**ADDENDUM NUMBER 1 TO RFCSP 2526.11-002
Rakow MS Parking Lot Addition**

22286.0000 – RISD URSULA RAKOW MS PARKING LOT ADDITION

Addendum: 001 Prepared By: Paige Russell

Summary of Revisions

**SOUTH PAVING PLAN
REVISED**

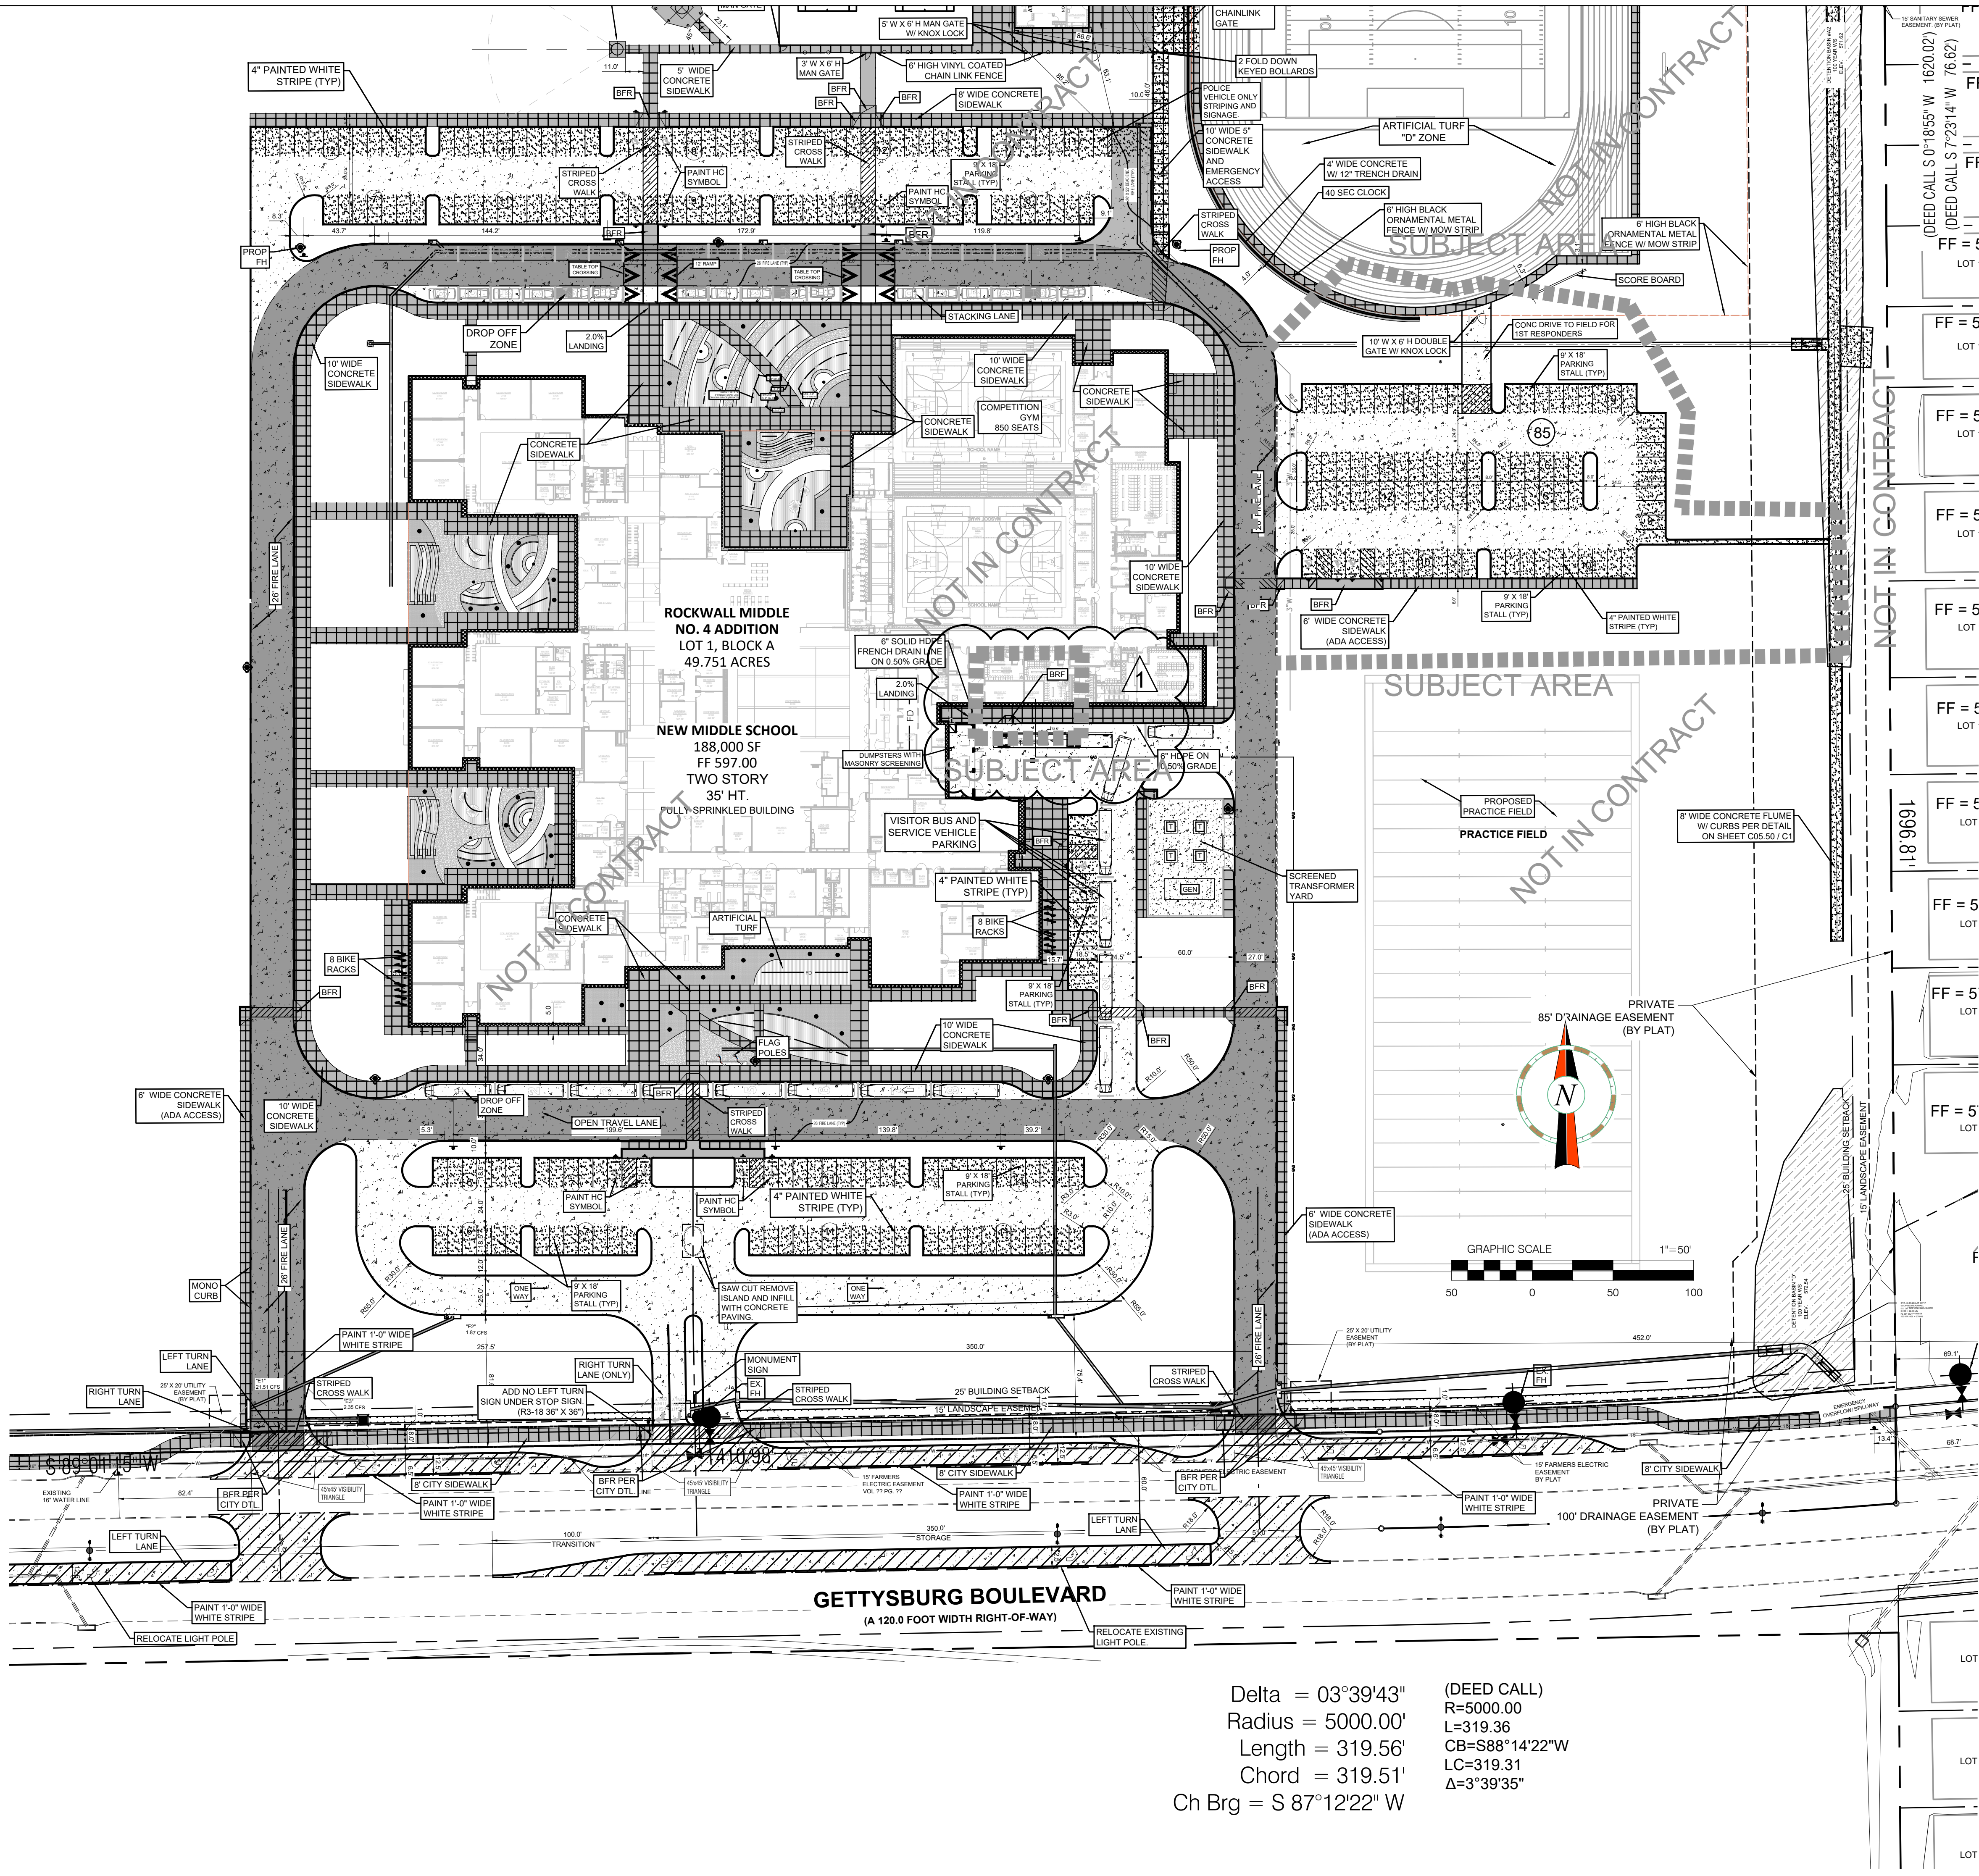
ITEM NO. 1.01 – SHEET C06.01 – SOUTH PAVING PLAN

- Add ADA pedestrian ramp near kitchen entrance.
